# County of Fairfax, Virginia

## STAFF REPORT

SPECIAL PERMIT APPLICATION NO. SP 2016-SP-032

**APPLICANT:** Ambassadors for Jesus Arabic Evangelical Church

STORM WATER MANAGEMENT REQUIREMENTS- PLANS  
**AMBASSADORS FOR JESUS**  
 SPRINGFIELD DISTRICT  
 FAIRFAX COUNTY, VIRGINIA

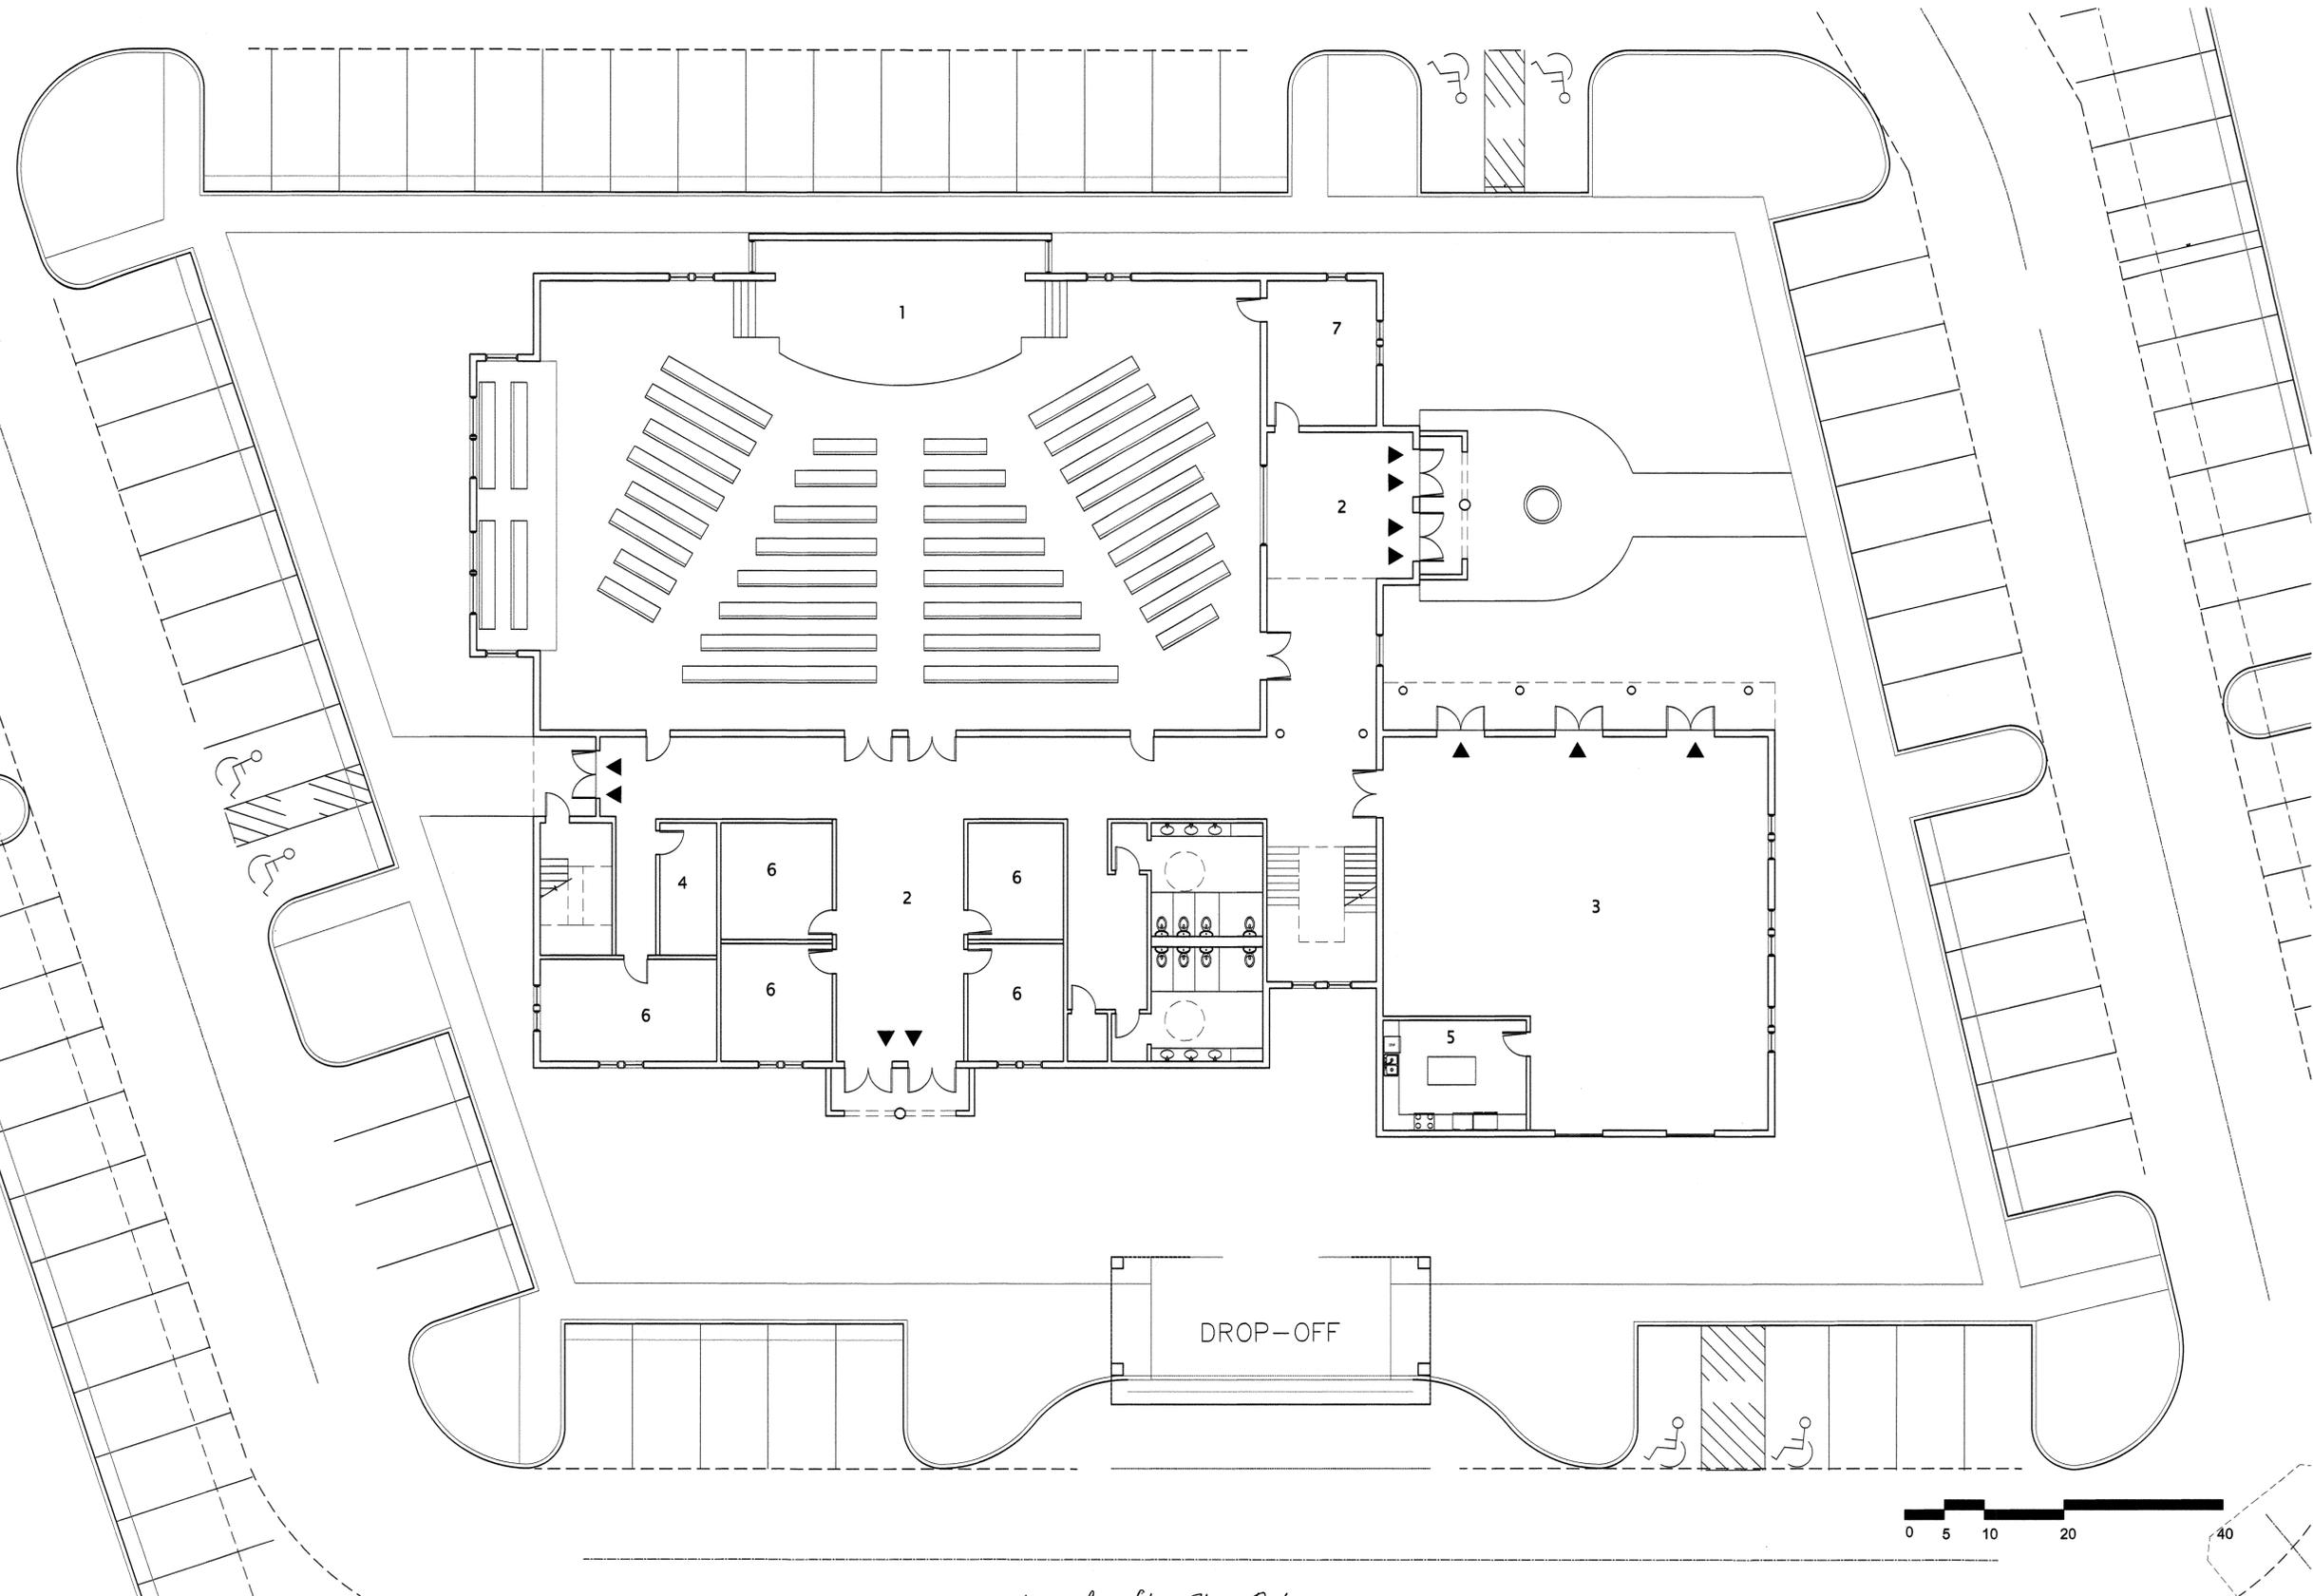
Applicant stated on sheet #5 that the detention requirements will be met for this development by providing underground SWM system. Detention requirements must be met if not waived (PFM 6-0301.2).

Applicant stated on sheet #5 that the water quality requirements will be met for this development using Filterra and Stormfilter. The VRRM spreadsheets demonstrating compliance with the water quality requirement for the redevelopment as per Chapter 124 of the County Code has been provided on sheet #6 but the drainage area sheet demonstrating how much area is treated by Filterra and Stormfilter is still missing in the plan.

Figure 3: Elevation of proposed structure, provided by applicant

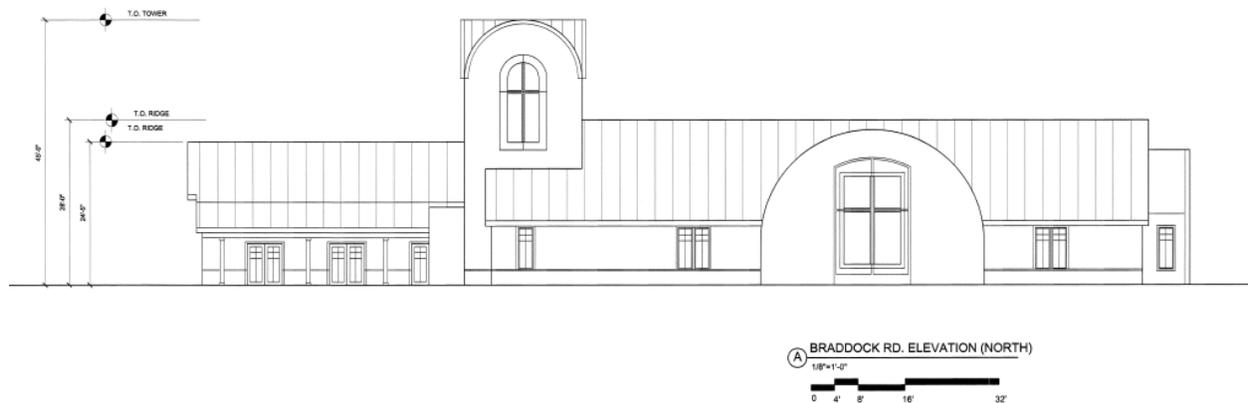
A development condition has been included requiring the sanctuary building to be generally consistent with the submitted architectural elevations.
